CITY OF KELOWNA

MEMORANDUM

APPLICATION NO. DP08-0234

TO APPROVE A DEVELOPMENT PERMIT FOR THE FORM AND CHARACTER OF THE PROPOSED 4 STOREY, 39-UNIT MIXED-USE

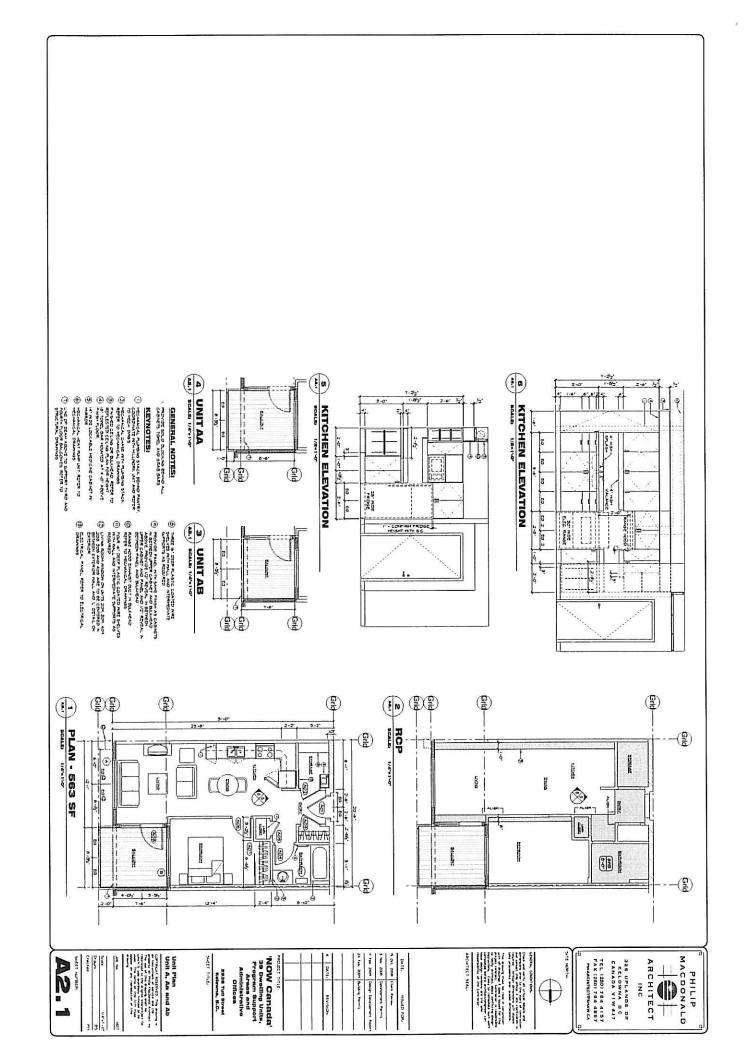
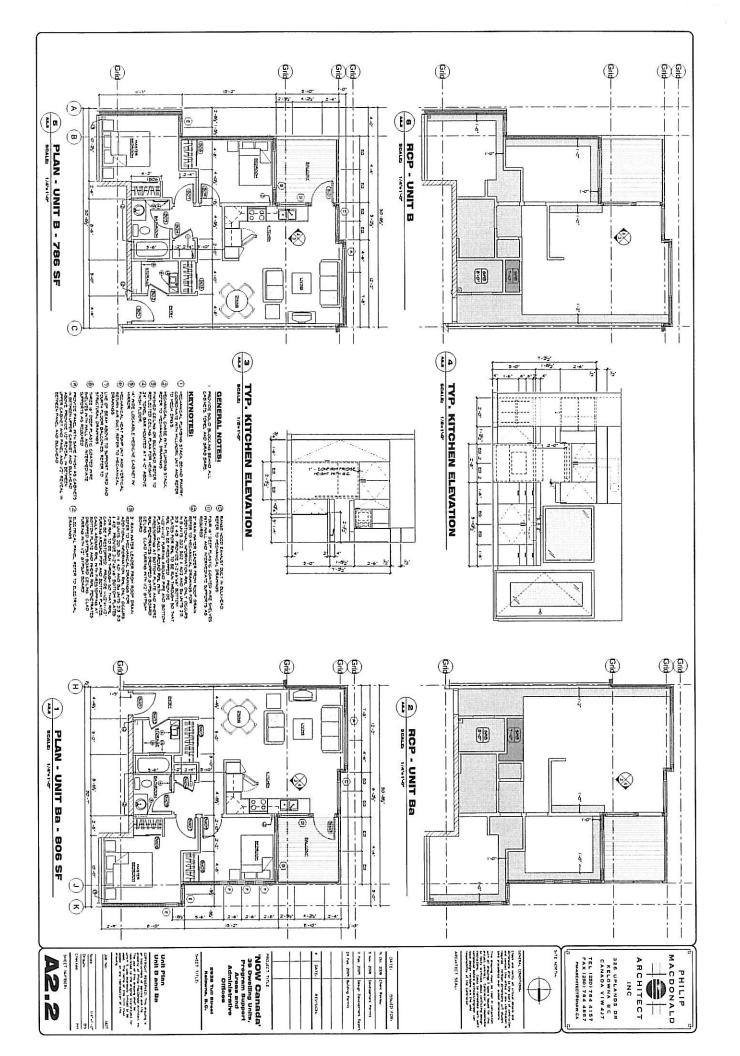
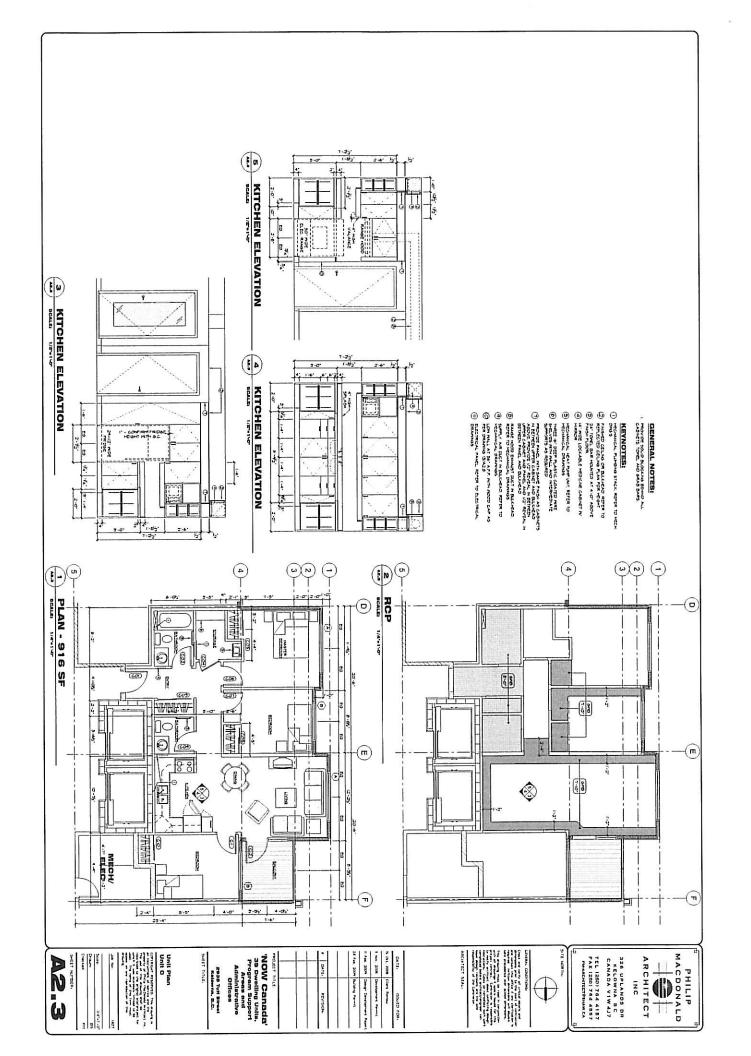
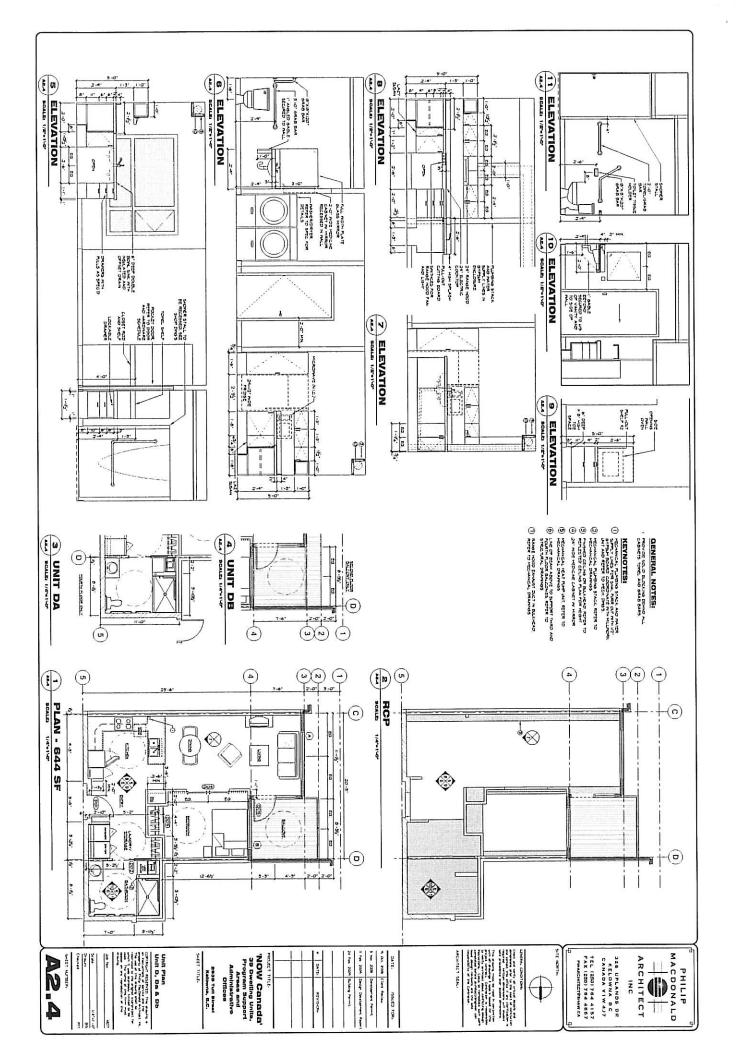
Door from stair shaft from residential floors (south elevation) to exit corridor to swing in direction of exit travel. Exit stair shaft from residential floors (north elevation) located in parkade must exit directly to exterior of building at laneway.

- Fire protection information not provided; fire department connection not shown.
- It appears fire flows for the complex will not be met. Engineered fire flows are required to determine if existing hydrants/fire flows are adequate and if additional hydrants/fire flows are required.
- The north exit stairs can not open into the parkade; the door is to swing in the direction of travel in the south exit stair shaft.
- The fire department does not allow grasscrete as a surface for fire department access; confirmation the grasscrete area is not part of the fire department access.
- Detailed building code analysis (detail equivalencies, if any) required for proposed building; to include exiting, fire protection information, fire department access, occupancy class, building height, construction type, among other things.
